# Village of Northbrook

## PUBLIC WORKS COMMITTEE

**TO:** Public Works Committee  
**FROM:** Matt Morrison, Assistant Public Works Director  
**DATE:** January 16, 2019  
**SUBJECT:** Tree Permit Review - 1227 Eastwood Lane

#### **Request for Tree Permit**

DEMOLITION, & PROPOSED FENCES PLAN

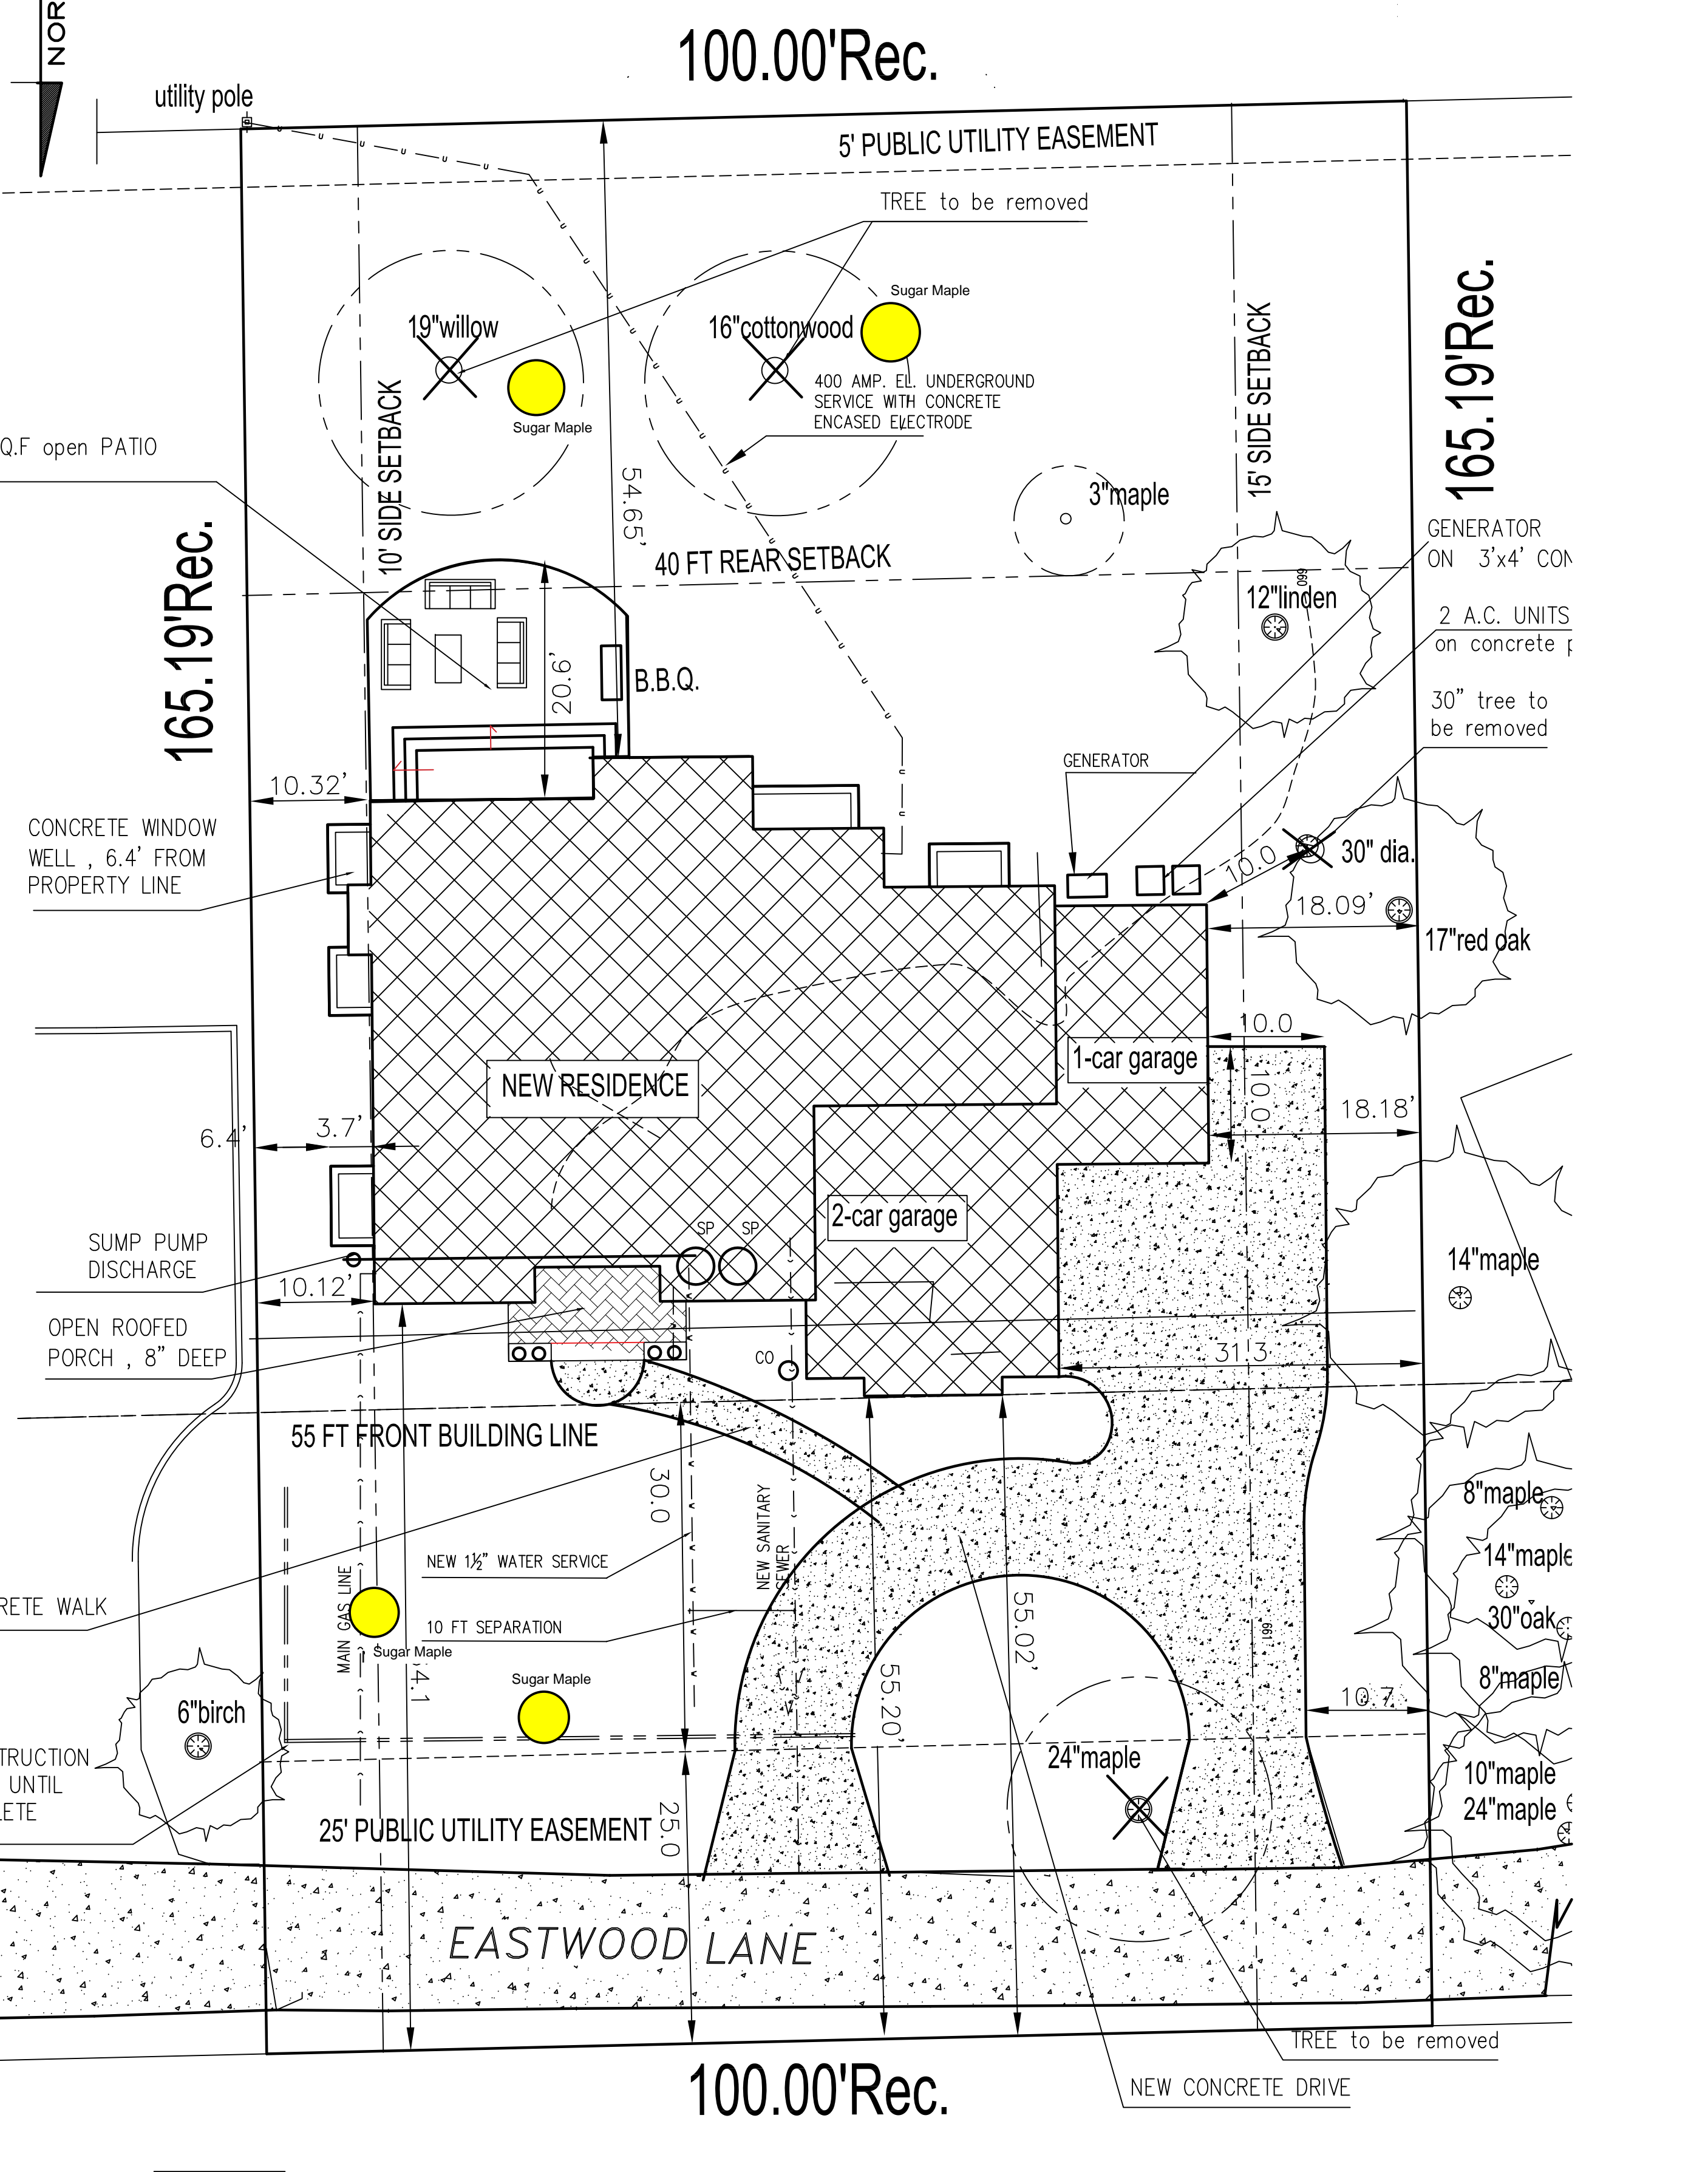
The property owner is requesting the removal of two landmark trees, a 31 inch diameter Black Walnut tree and a 25 inch diameter Sugar Maple tree. The Black Walnut remains in average health while the Maple is declining but not dead. Staff does not disagree with the ratings of the property owner's arborist. The Black Walnut is in conflict with the construction of the garage of the new home and the Maple is in conflict with the construction of the new circular driveway.

Staff recommends that the Public Works Committee recommend removal of the landmark trees as they are in conflict with the proposed new home and will decline to a point of dying or becoming a hazard as a result of the holes drilled/bored into the base of the trees. Given the nature of the holes drilled/bored into the trees and the residue weeping from them, staff recommends that the full fees of \$8,400 be assessed and not reduced by replanting on the property. Consistent with other landmark and tree removals considered by the Public Works Committee, staff recommends that a condition of tree removals be that the wood from the trees be reused for a purpose other than firewood, mulch, or wood chips and preferably be used in the construction of the new home. Lastly, that the property owner and their contractor should be required to take aggressive measures to preserve all other trees on this and neighboring properties.
